EA-18-104

**SUBJECT: CLINTON POWER STATION - FINAL SIGNIFICANCE DETERMINATION OF A
WHITE FINDING WITH ASSESSMENT FOLLOW-UP AND NOTICE OF
VIOLATION; NRC INSPECTION REPORT NO. 05000461/2018092**

Final Significance Determination

A. Summary of Final Significance Determination

Figure 1: Loss of Offsite Power (LOOP) Event Tree

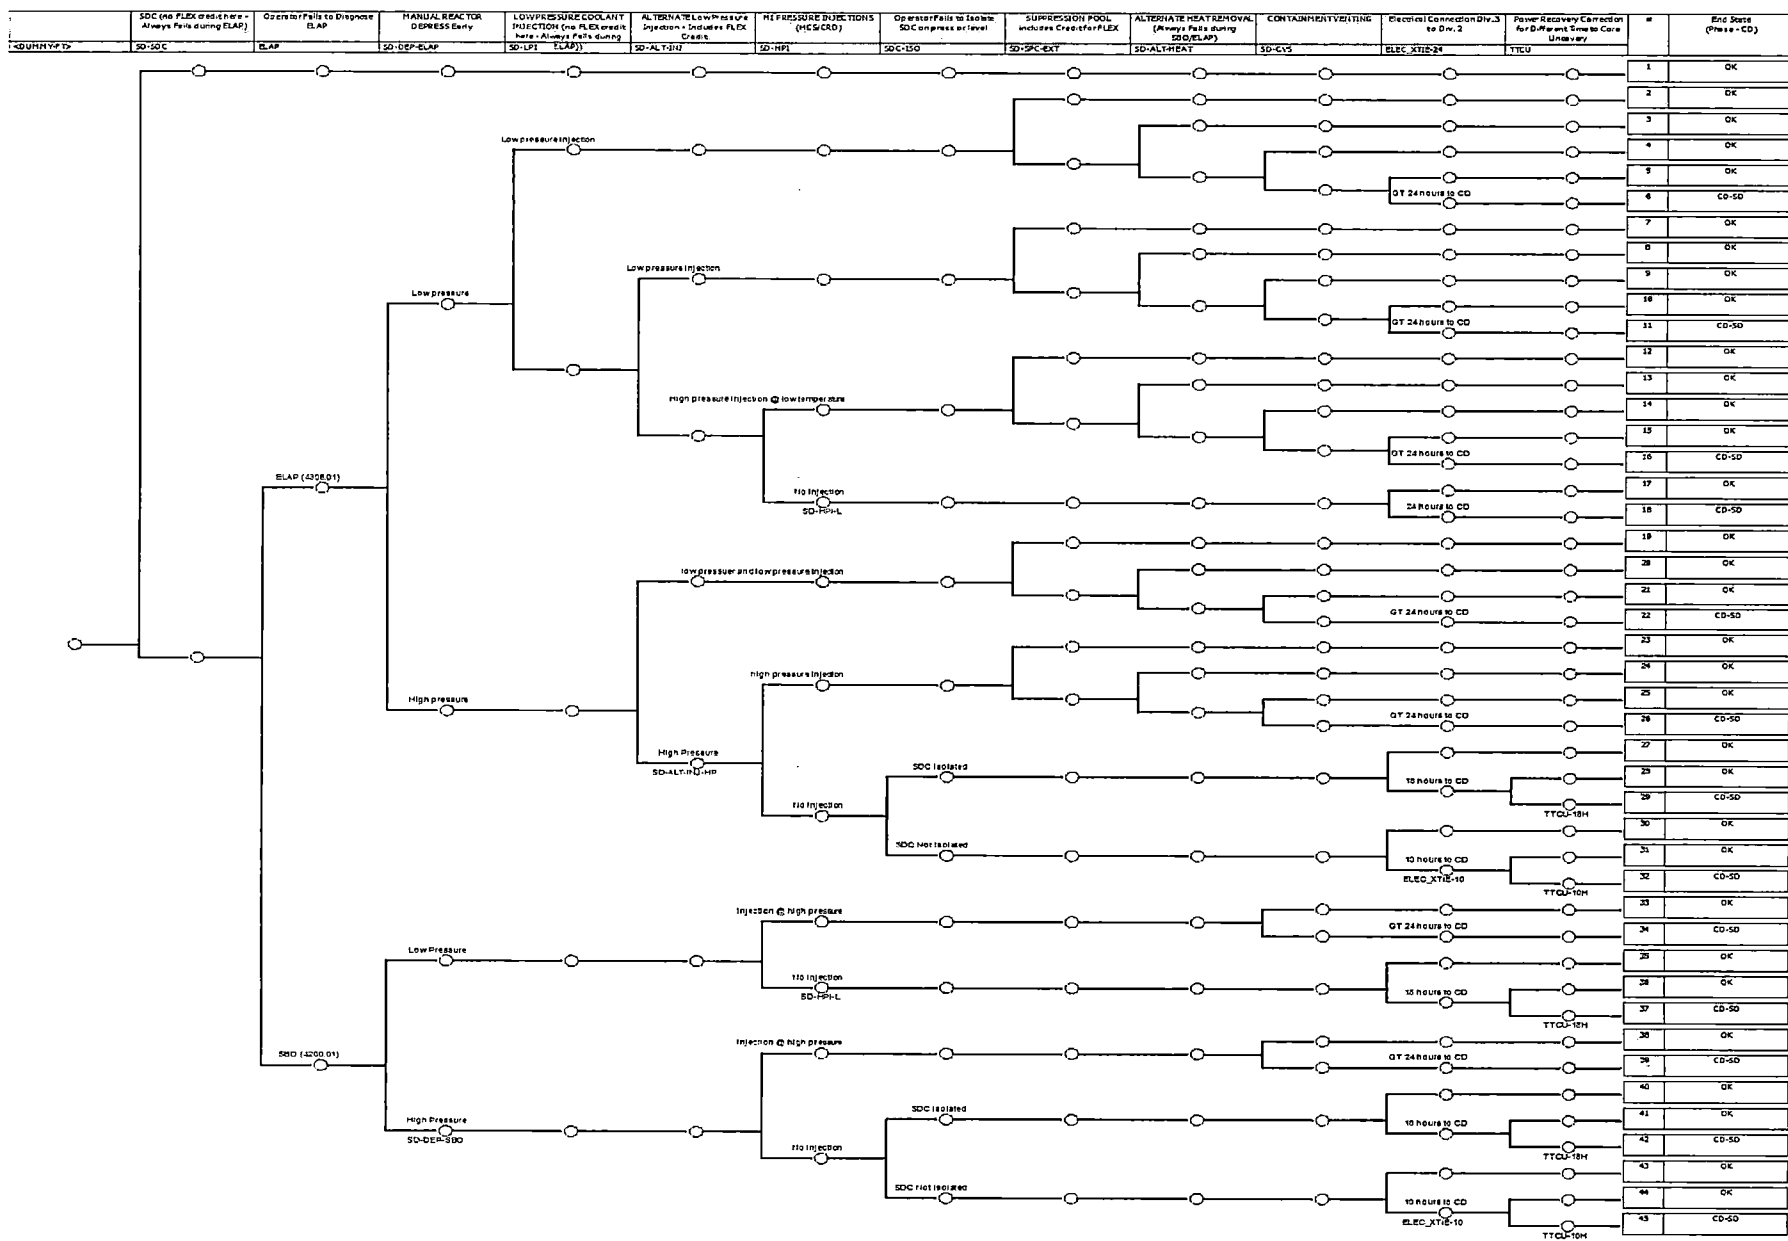
The new information led to changes to the event tree (ET) structure used to quantify the risk. This ET is shown in Figure 1 below. The top two dominant core damage sequences were Sequences 18 and 37. Sequence 18 includes: LOOP initiates, failure of the emergency diesel generators (EDG), failure to recover either of the two EDGs and offsite power, successful ELAP diagnosis, successful early reactor depressurization, failure of low pressure injection (including FLEX), failure of high pressure injection, and failure of the Division 3 to Division 2 cross-tie. Sequence 37 includes: LOOP initiates, failure of the EDG, failure to recover either of the two EDGs and offsite power, failure to diagnose ELAP, successful early reactor depressurization, failure of high pressure injection, failure to perform the cross-tie.

To incorporate this new information, the NRC modified its risk analysis by adding a new event tree (ET) top event that tested for failure to isolate the RHR/SDC system from the RCS on high reactor pressure and decreasing reactor level. The modified ET is shown in Figure 1. This top event was evaluated using a new fault tree (FT). The FT tests for all three cues discussed above.

The event tree (see Figure 1) tests for successful depressurization. If depressurization is successful, then time to core uncover is extended allowing additional time for subsequent mitigation actions.
